P02: Please include project number PR-000199-2023

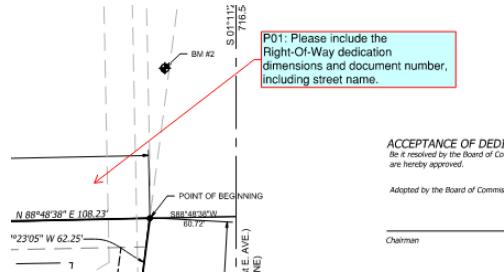
P01: Please include the Right-Of-Way dedication dimensions and document number, including street name.

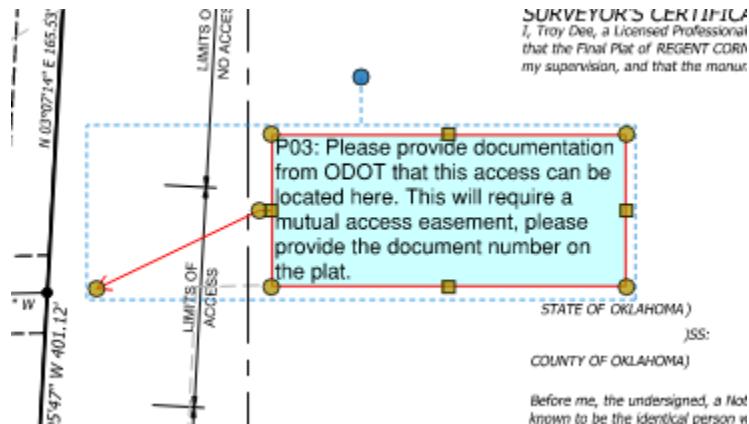
P03: Please provide documentation from ODOT that this access can be located here. This will require a mutual access easement, please provide the document number on the plat.

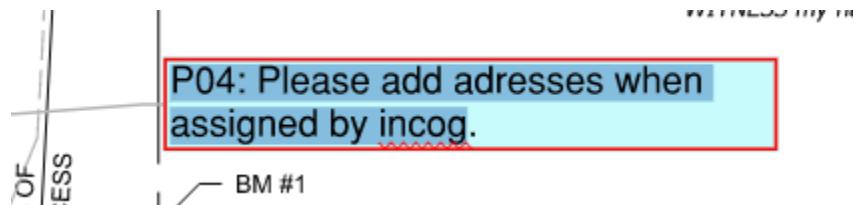
P04: Please add addresses when assigned by incog

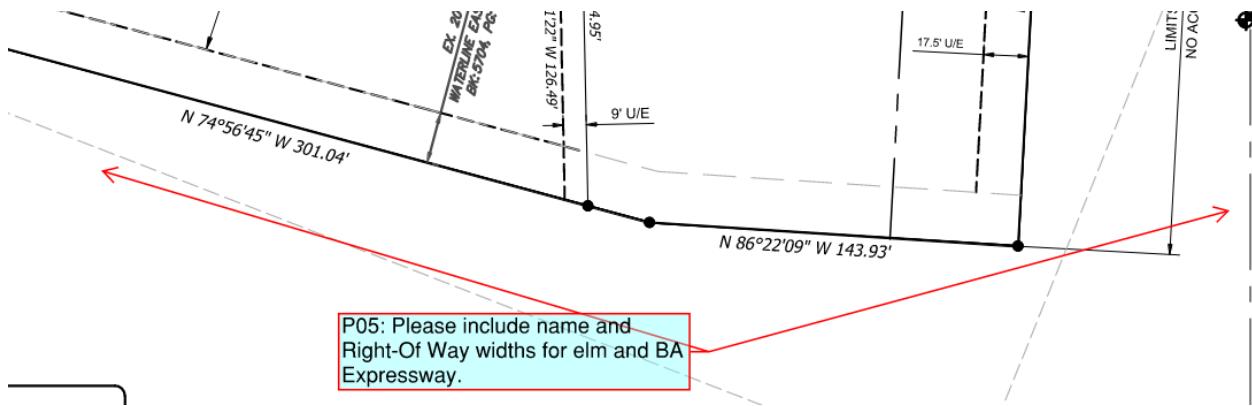
P05: Please include name and Right-Of Way widths for elm and BA Expressway.

E01. Please note the Detention Determination Number on this plat
